Serial No.: 10/519,716
Docket No.: 28957.0125

REMARKS

FIG. 2

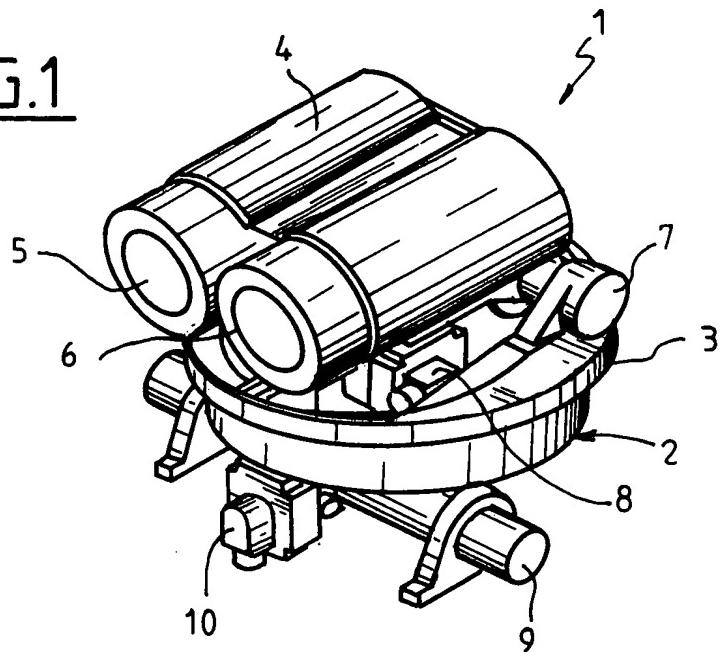
Applicants have amended Figure 2 to illustrate axis 14. Corrected drawing sheets in compliance with 37 CFR 1.121(d) accompany this Amendment.

2. Applicants' have corrected the drawings to illustrate axis 14, mooted the objection thereto.
